SAFETY EVALUATION BY THE OFFICE OF NUCLEAR REACTOR REGULATION

RELATING TO THE OFFSITE DOSE CALCULATION MANUAL

POINT BEACH NUCLEAR PLANT, UNIT NOS. 1 AND 2

DOCKET NOS. 50-266 AND 50-301

Figure 2-2

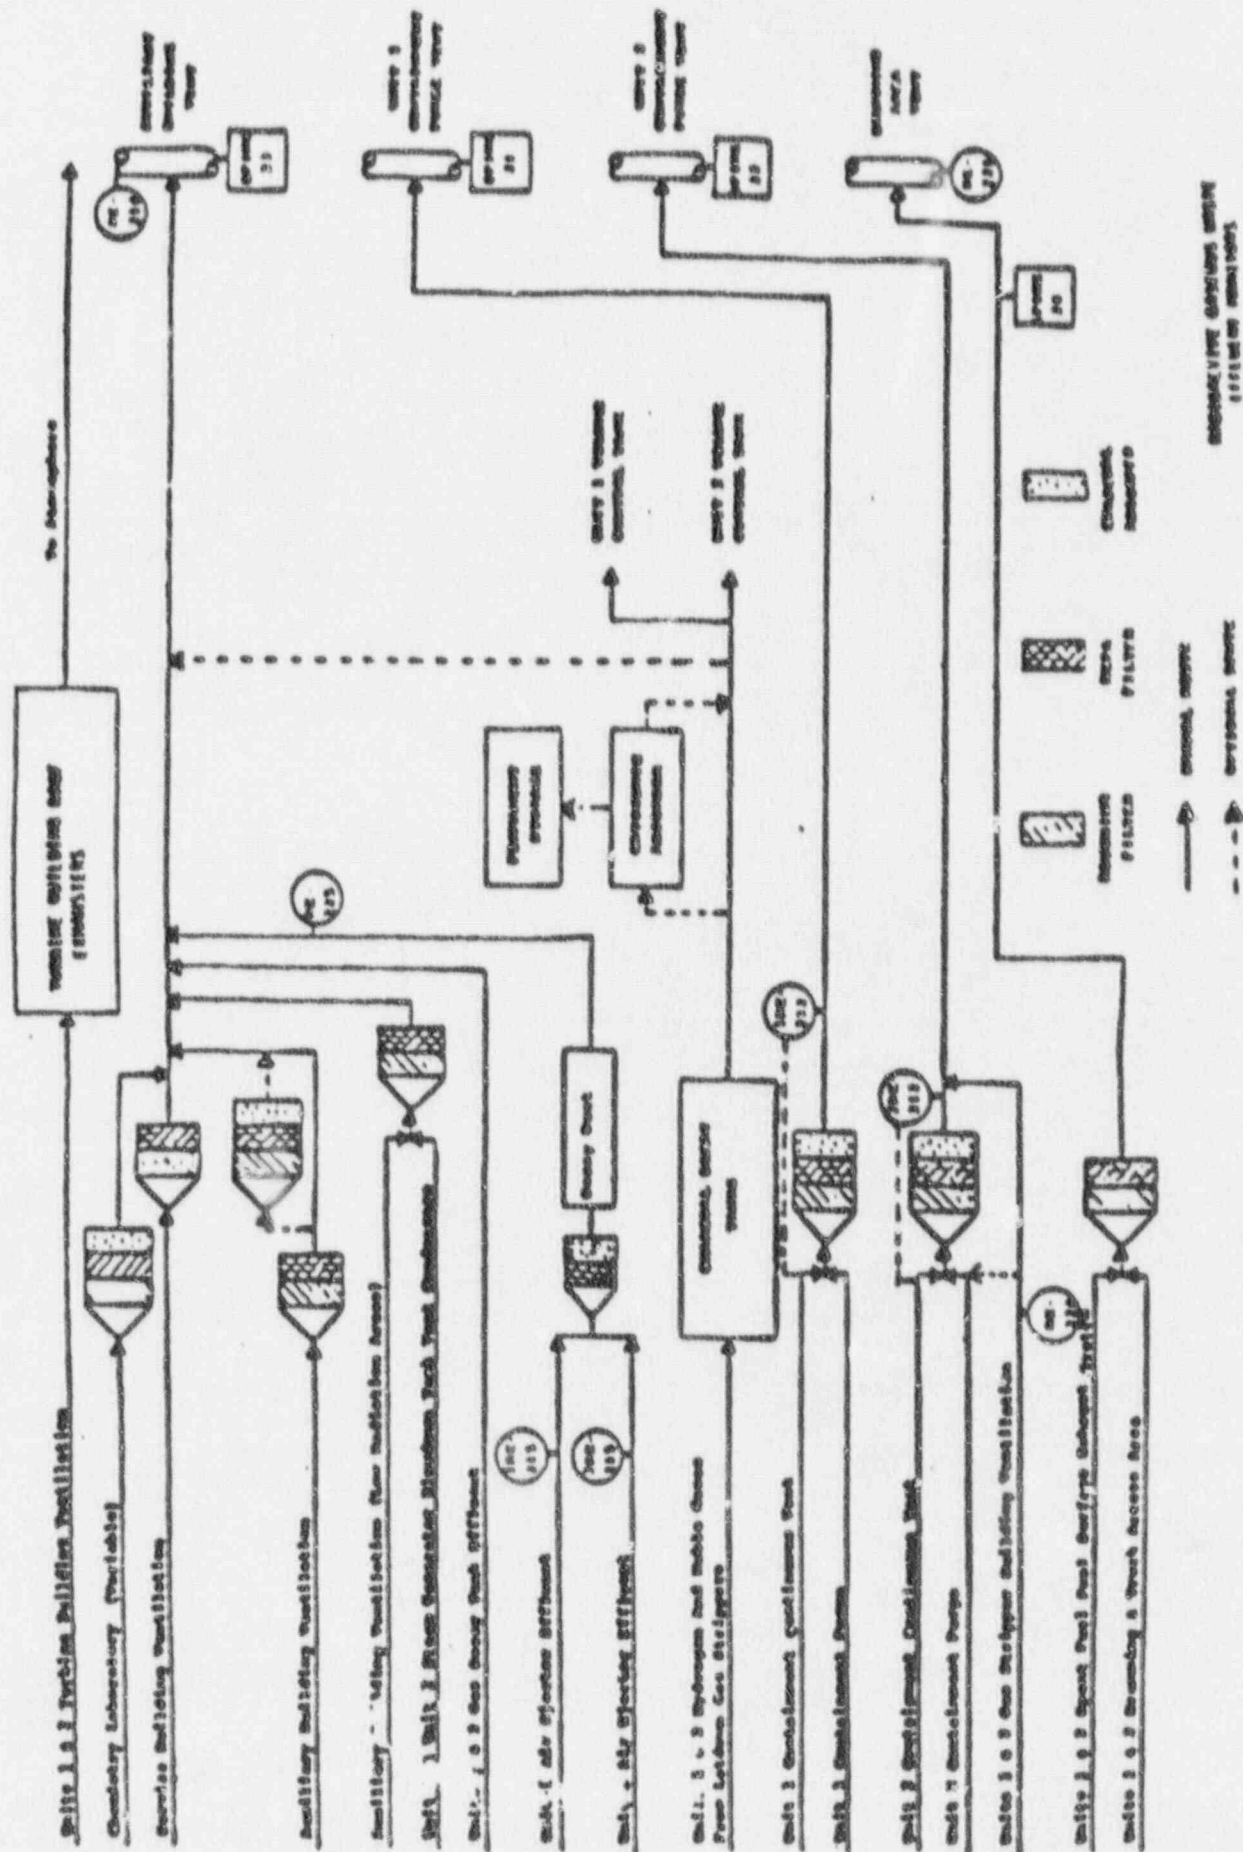
- (12) In Table 5-1, the ratio term for Te-131m should be $1.49E-01$ instead of $1.49E-02$.
- (13) A simplified diagram for the gaseous waste treatment system is supposed to be in Figure 2-2. However, Figure 2-2 is a repeat of the liquid radwaste treatment system which is shown in Figure 2-1 of the ODCM.

The ratio term to Te-131m in Table 5-1 and the gaseous waste treatment system diagram of Figure 2-2 were corrected in the September 1987 revision to the ODCM. A copy of the correct figure is attached herewith.

- (12) The Licensee's response is considered acceptable, since the erroneous ratio term was corrected in the September 1987 revision of the ODCM.
- (13) The Licensee's response is considered acceptable since the proper figure was used in the September 1987 revision of the ODCM.
